Section 16 Application for A\_NE-MKT\_47

**Response to Departmental Comments Table**

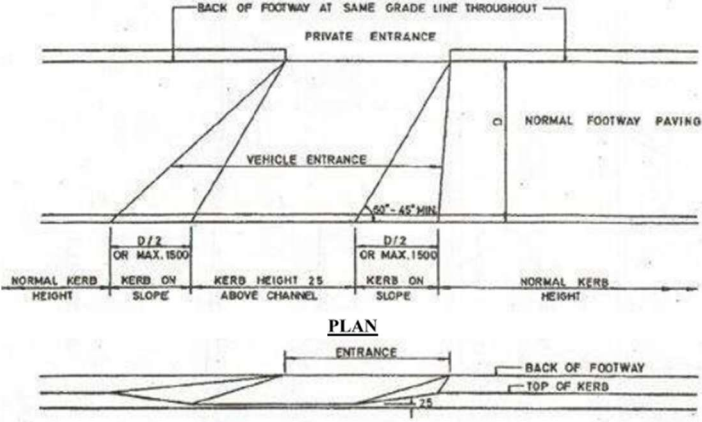
5.	<p>The applicant should be advised of the following general requirements in the drainage proposal:</p> <ul style="list-style-type: none"><li>(i) surface channel with grating covers should be provided along the site boundary;</li><li>(ii) a drainage plan should be provided clearly showing the size, levels and routes of the proposed drainage. The details (invert level, gradient, general sections, etc.) of the proposed drain/surface channel, catchpits and the discharge structure shall be provided;</li><li>(iii) the cover levels of proposed channels should be flush with the existing adjoining ground level;</li><li>(iv) a catchpit with covers should be provided where there is a change of direction of the channel/drain. The details of the catchpit with covers shall be provided;</li><li>(v) catchpits with sand trap shall be provided at the outlets of the proposed drainage system. The details of the catchpit with sand trap should be provided;</li><li>(vi) the applicant should check and ensure that the existing drainage downstream to which the proposed connection will be made have adequate capacity and satisfactory condition to cater for the additional</li></ul>	<p>Noted with thanks.</p> <p>The drainage proposal will be submitted in accordance of the approval condition of this planning application.</p>
